UNITED STATES PATENT AND TRADEMARK OFFICE

APPLICATION NO.	FILING DATE	FIRST NAMED INVENTOR	ATTORNEY DOCKET NO.	CONFIRMATION NO.
09/876,506	06/06/2001	Matthew D. Giere	10006598-1	9309

Office Action Summary

DETAILED ACTION

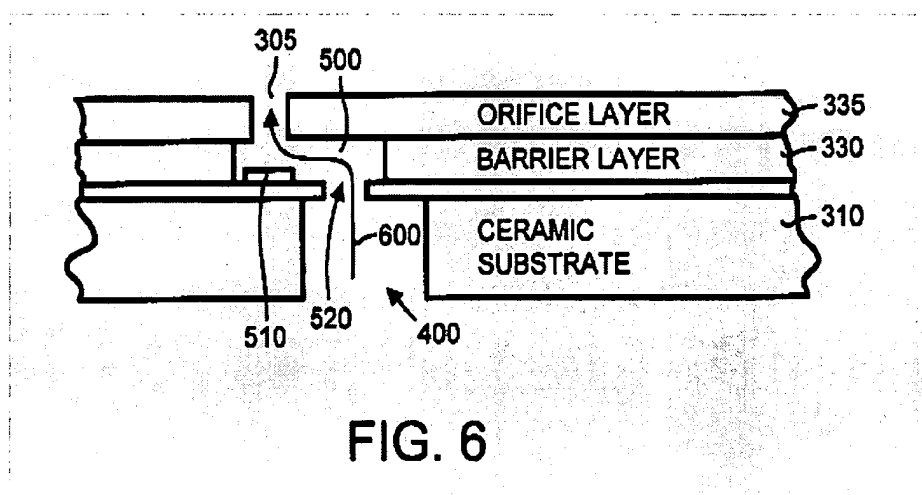
Childers et al. disclose an ink jet printhead comprising:

- a substrate (FIG. 6, element 310);
- an ink feed slot formed through the substrate (FIG. 6, element 400);
- a thin film layer (FIG. 6: the layer that is between layer 330 and layer 310)

disposed on a surface of the substrate (FIG. 6, element 310), the thin film layer defining a plurality of firing resistors (FIG. 6, element 510), a plurality of ink feed openings (FIG. 6, element 520) formed through the thin film layer to provide respective ink paths through the thin film layer from the ink feed slot (FIG. 6: the ink path 600);

a barrier/orifice structure (FIG. 6, elements 330 and 335) disposed on the thin film layer, the structure defining an array of nozzles arranged in a plurality of nozzles columns (FIG. 4A, element 420) and an array of firing chambers (FIG. 6, element 500) in correspondence with correspondence with the array of nozzles;

the firing resistors being arranged in correspondence with the firing chambers (FIG. 6, element 510 and FIG. 5, element 410);

the barrier/orifice structure further comprising a continuous rib portion extending between adjacent first and second ones of the plurality of nozzle columns to fluidically separate the first and the second ones of the nozzle columns (FIG. 5-6: the layers 330 and 335 extend in a direction that connects ink feed openings 520 of two nozzle columns);

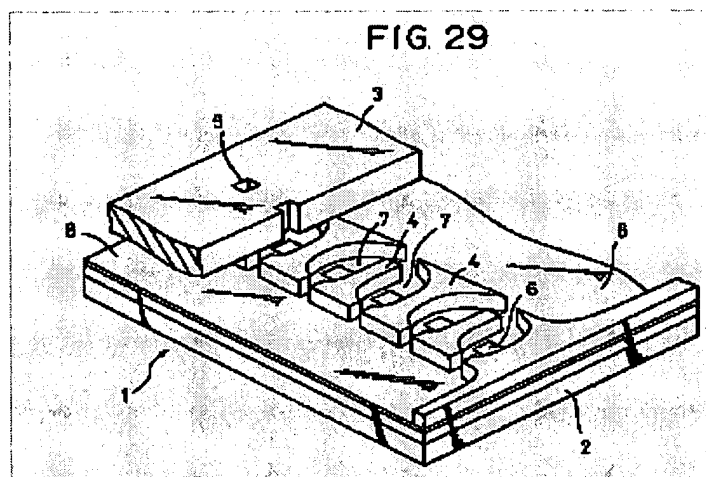
Steinfield et al. discloses a fluid ejecting printhead, comprising:

a substrate having a surface (FIG. 13, element 10), and a fluid supply formed through the substrate to the surface (FIG. 13, element 52);

a columnar group of drop generators (FIG. 14) formed on the surface that are arranged into subgroup (FIG. 14, three drop generators)

printhead electronics that provide firing pulses to the drop generators such that no drop generators in the same subgroup are activated sequentially or simultaneously (FIG. 14 and 16 and TABLE 1: For example, a first firing signal is sent to address (P1, A1) to fire nozzle 1, the next firing signal is sent to address (P1, A2) to fire nozzle 7).
